INSTRUCTION TO SERVICE

ITS61138		28-Aug-2024
SECTION:	219-Engine and Transmission (Oil level dipstick)	
SUBJECT:	Replace the Cummins supplied oil level dipstick support bracket with a NF designed version.	
ISSUE:	Existing Cummins oil level dipstick support p-clip breaks due to stress.	
SUMMARY:	Replace the Cummins supplied oil level dipstick support bracket with a NF designed version due to Cummins not having a better option.

Figure 2: Existing Oil Tube Dipstick Support Bracket Removal

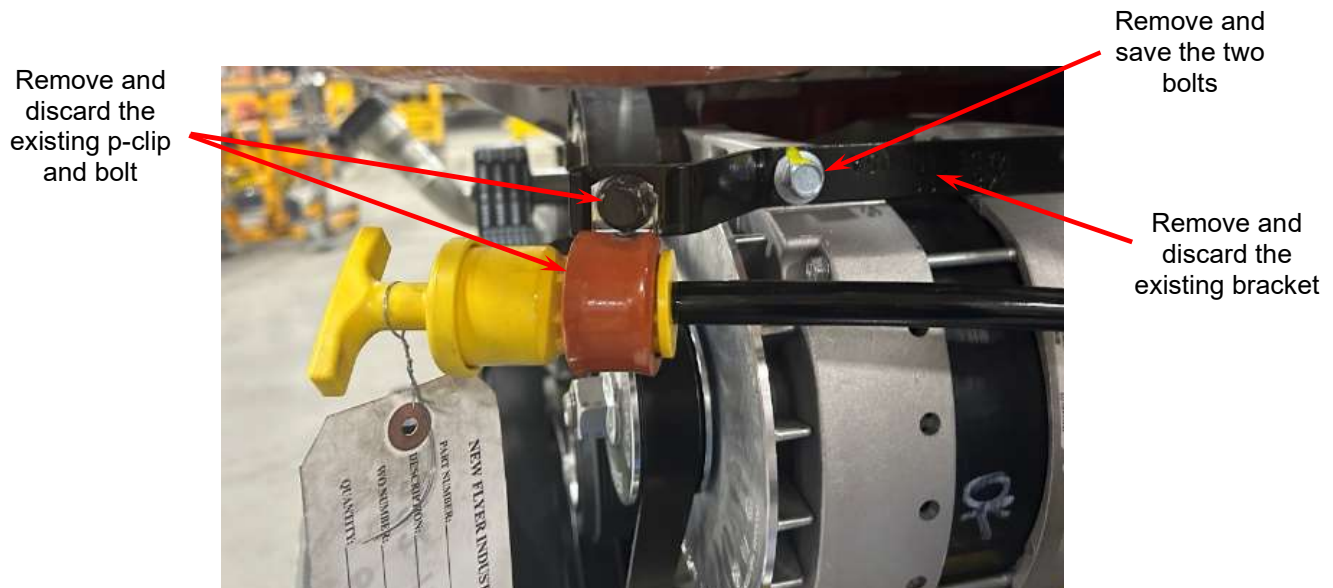
4. Remove and discard the existing p-clip and bolt, tie back the oil tube.
5. Remove and save the two bolts securing the oil tube support bracket and alternator to the engine, discard the bracket.

Figure 3: New Oil Tube Dipstick Support Bracket Installation

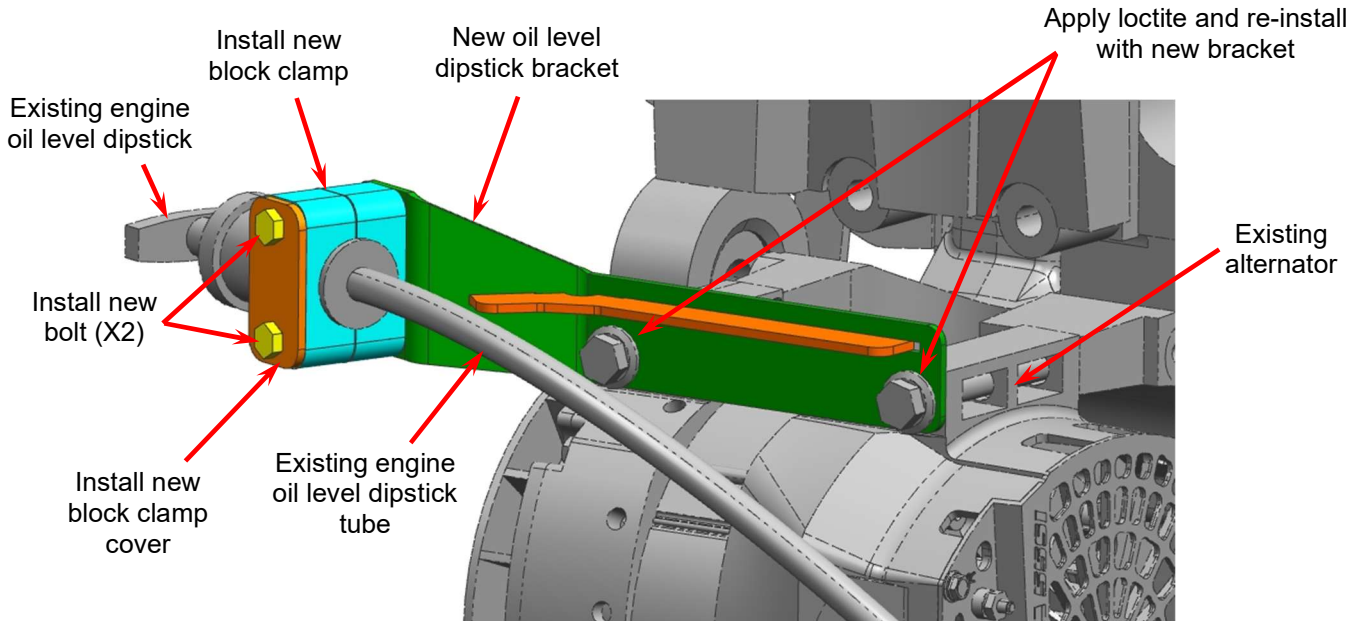
6. Apply loctite to the bolt threads removed in Step 5 and install new bracket p/n 1095415 in the same location and orientation as shown in Figure 3, torque bolts to 33-35 ft*lbs.
7. Secure the oil dipstick tube tied back in Step 4 to the newly installed bracket as shown in Figure 3 using clamp p/n 502245, cover plate p/n 068497 and bolt p/n 20B04036 (x2), apply loctite p/n 081034 to the bolt threads prior to installation.
